SUBJECT: SURRY UNITS 1 AND 2 - ISSUANCE OF AMENDMENTS RE: SURRY, UNITS
1 AND 2 REACTOR VESSEL HEATUP AND COOLDOWN CURVES
(TAC NOS. M92537 AND M92538)

AMENDMENT NO. 207 TO FACILITY OPERATING LICENSE NO. DPR-32 - SURRY UNIT 1
AMENDMENT NO. 207 TO FACILITY OPERATING LICENSE NO. DPR-37 - SURRY UNIT 2

SAFETY EVALUATION BY THE OFFICE OF NUCLEAR REACTOR REGULATION
RELATED TO AMENDMENT NO. 207 TO FACILITY OPERATING LICENSE NO. DPR-32
AND AMENDMENT NO. 207 TO FACILITY OPERATING LICENSE NO. DPR-37
VIRGINIA ELECTRIC AND POWER COMPANY
SURRY POWER STATION, UNIT NOS. 1 AND 2
DOCKET NOS. 50-280 AND 50-281

Surry Units 1 and 2 Reactor Coolant System Heatup Limitations (Heatup Rates up to 60 F/hr) Applicable for the First 28.8 EFPY for Surry Unit 1 and the First 29.4 EFPY for Surry Unit 2

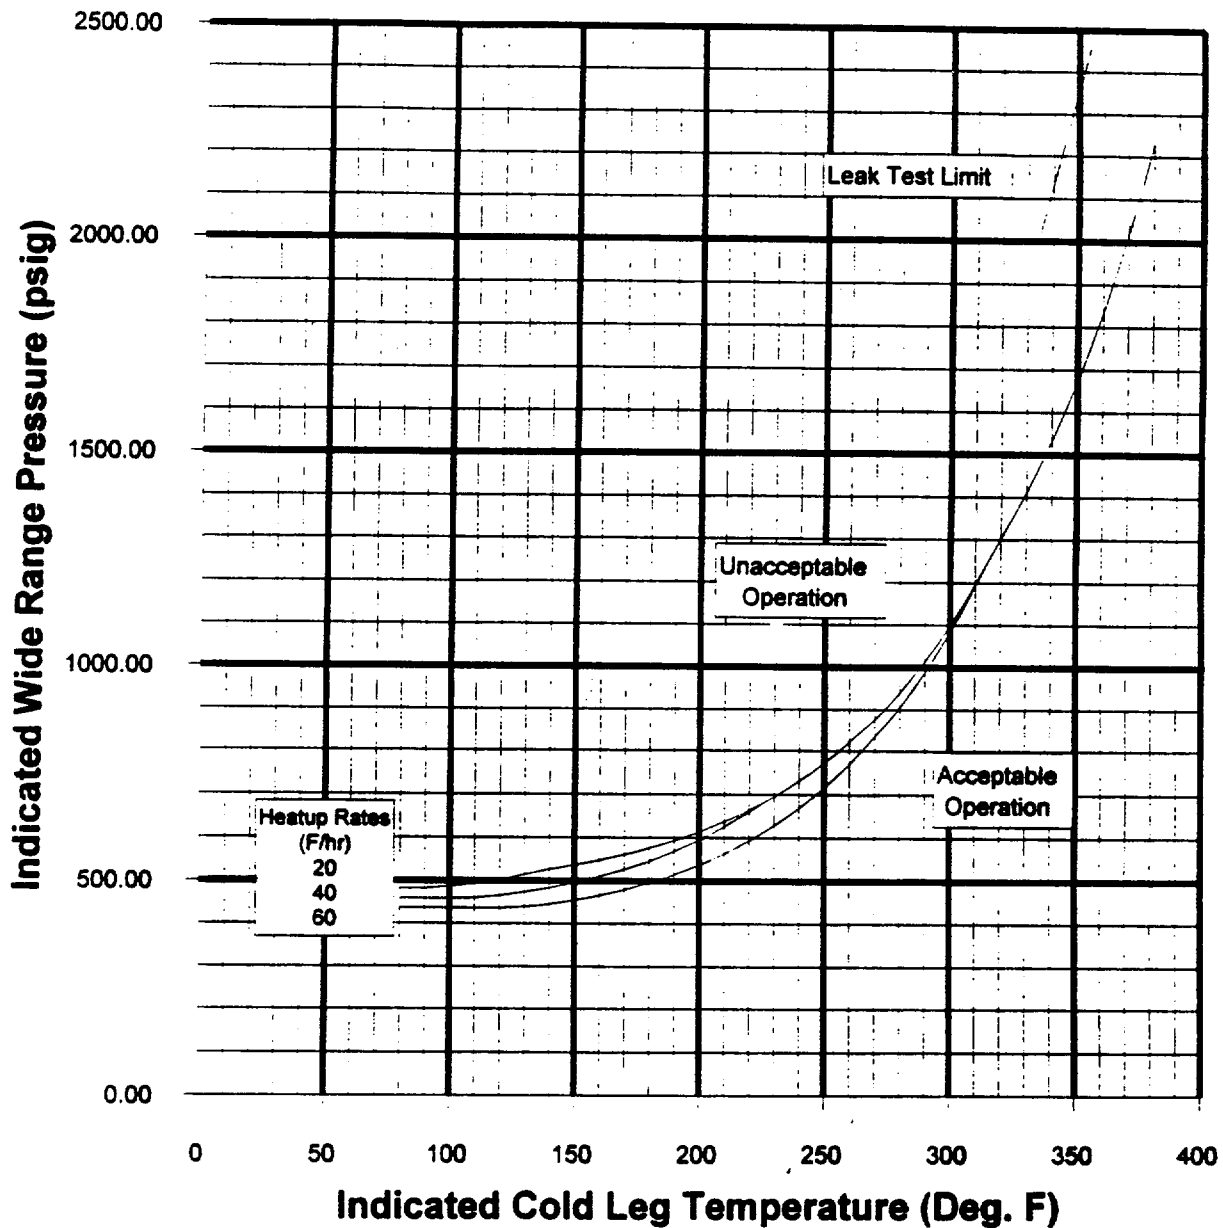
1. Unit 1 and Unit 2 reactor coolant temperature and pressure and the system heatup and cooldown (with the exception of the pressurizer) shall be limited in accordance with TS Figures 3.1-1 and 3.1-2.

Figure 3.1-1 may be used for heatup rates of up to 60°F/hr.

The heatup limit curve, Figure 3.1-1, is a composite curve which was prepared by determining the most conservative case, with either the inside or outside wall controlling, for any heatup rate up to 60°F per hour. The cooldown limit curves of Figure 3.1-2 are composite curves which were prepared based upon the same type analysis with the exception that the controlling location is always the inside wall where the cooldown thermal gradients tend to produce tensile stresses while producing compressive stresses at the outside wall. The cooldown limit curves are valid for cooldown rates up to 100°F/hr. The heatup and cooldown curves were prepared based upon the most limiting value of the predicted adjusted reference temperature at the end of 28.8 EFPY and 29.4 EFPY for Units 1 and 2, respectively. The adjusted reference temperature was calculated using materials properties data from the B&W Owners Group Master Integrated Reactor Vessel Surveillance Program (MIRVSP) documented in the most recent revision to BAW-1543 and reactor vessel neutron fluence data obtained from plant-specific analyses.

Surry Units 1 and 2 Reactor Coolant System Cooldown Limitations (Cooldown Rates up to 100 F/hr) Applicable for the First 28.8 EFPY for Surry Unit 1 and the First 29.4 EFPY for Surry Unit 2

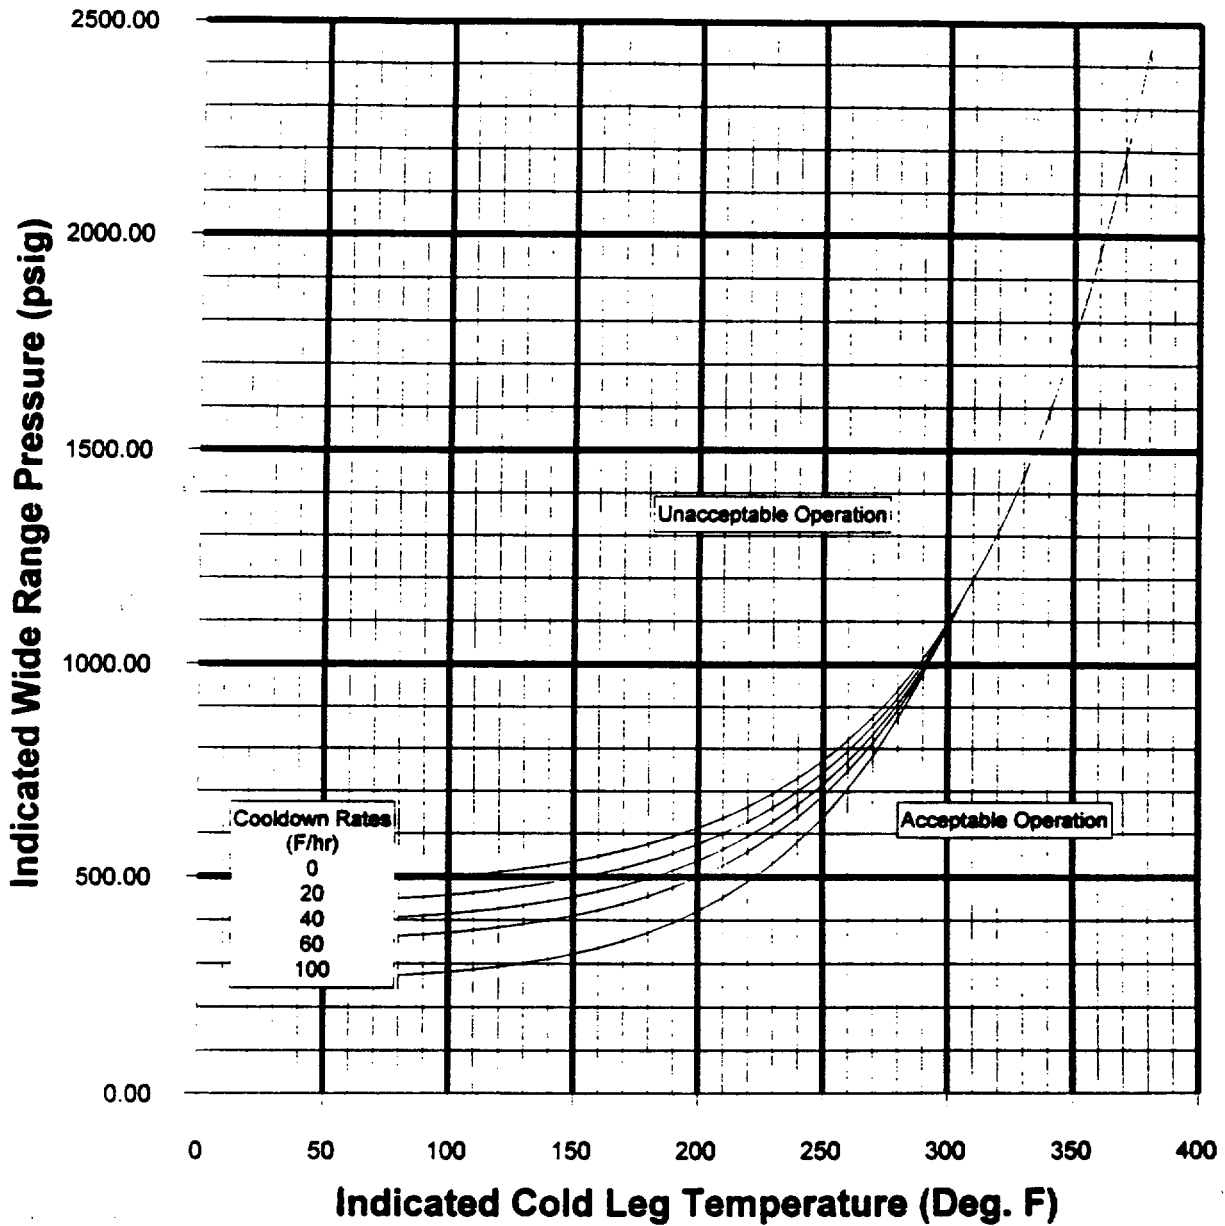
Allowable combinations of pressure and temperature for specific cooldown rates are below and to the right of the limit lines as shown in TS Figure 3.1-2. This rate shall not exceed 100°F/hr. Cooldown rates between those shown can be obtained by interpolation between the curves on Figure 3.1-2.
